RE: Anasazi Ridge Unit 3
Drainage Report, Engineer's Stamp Date: 05/09/18
Supplemental Rundown Calculations, Engineer's Stamp Date: 05/09/18
Grading and Drainage Plan, Engineer's Stamp Date: 05/09/18
Hydrology File: A10D002G

Anasazi Ridge Unit 3
Subdivision

Supplemental Information
To
Drainage Management Plan
(dated 1-12-15)

Re: Anasazi Ridge Unit 3 Drainage Report, Engineer's Stamp Dated 10/24/14

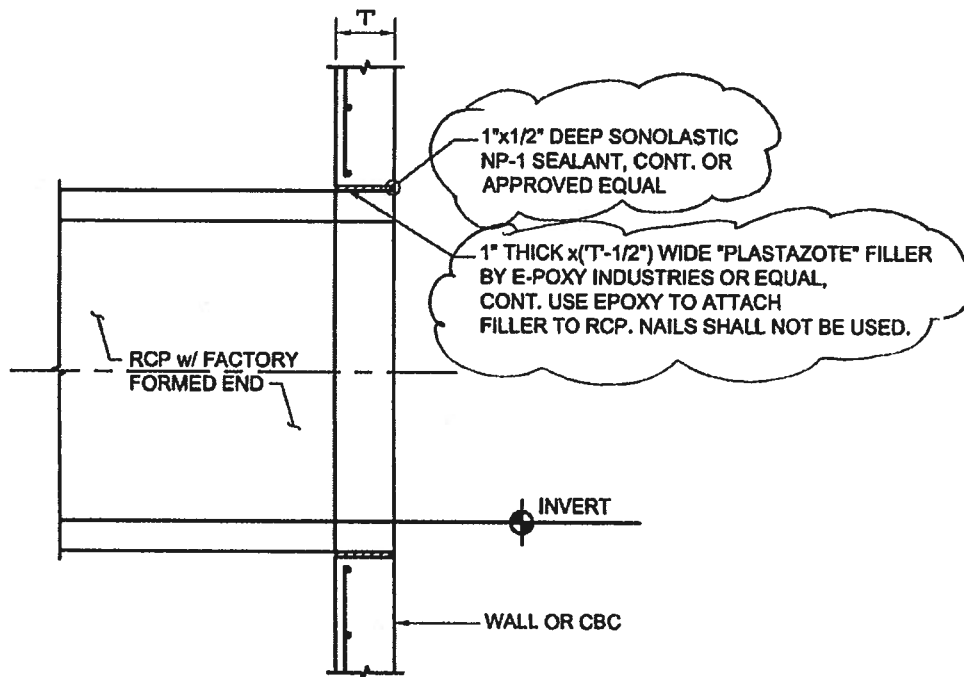
6. AMAFCA will require a removable trash screen close to the removable bollards to collect large debris before it flows into the arroyo. See attached detail.

1. Agreed. There is a triangular parcel of property at the southeast corner of McMahon Blvd. and Kayenta Blvd. that is owned by someone other than AMAFCA. The proposed rundown improvements will remain outside this parcel of property and remain within the public McMahon Blvd. right of way as shown on the revised grading plan.
2. The temporary 10' wide channel rundown has been added to the city infrastructure list. Whoever is maintaining the existing temporary asphalt rundown should maintain the concrete rundown. I assume this is and will be the City of Albuquerque.
3. The proposed channel is entirely within the McMahon Blvd right of way, so a license should not be necessary.
4. Ok.
5. Ok.
6. Ok. These details can be worked out during DRC approval process.

Hydraulic Analysis of the Spillway to Vizcaya Road Transition

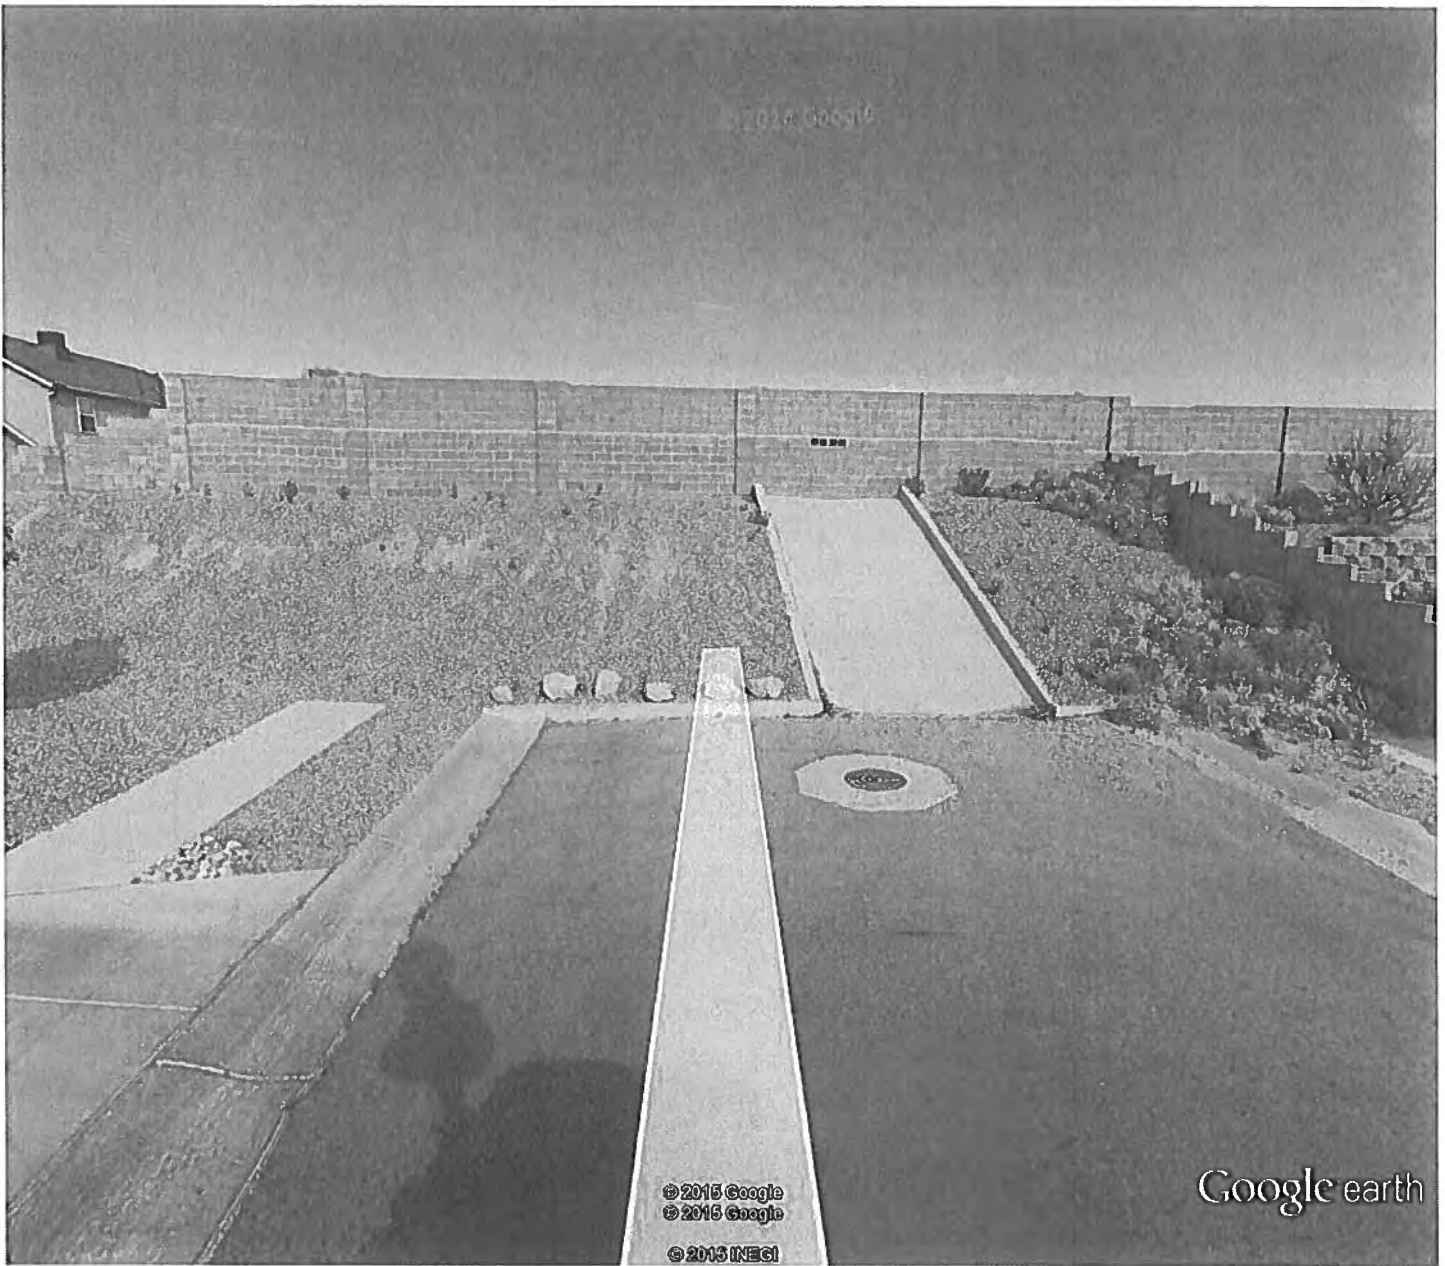
The results of the HEC-2 analysis indicate that the WSEL in Vizcaya immediately downstream will be between 0.34' to 0.39'. While this is above the top of curb height for mountable curb. It is within the maximum 0.53' height that would typically exist at the property line.

It is proposed that the 8' wide channel be constructed to line up with the flow along the north side of Vizcaya Road and that the landscape rock along this side of the road be replaced with 4" concrete section from the spillway channel all the way to the intersection of Calle Gandia Road, which is a distance of approximately 80 lineal feet. This should provide adequate protection against any flow that may top the curb in this area.

Because the channel is being constructed away from the homes located on the south side of Vizcaya Road, and there will be some distance downstream before the spread of runoff would extend all the way to the south side of the road, it should not be necessary to replace the landscape rock on the south side.
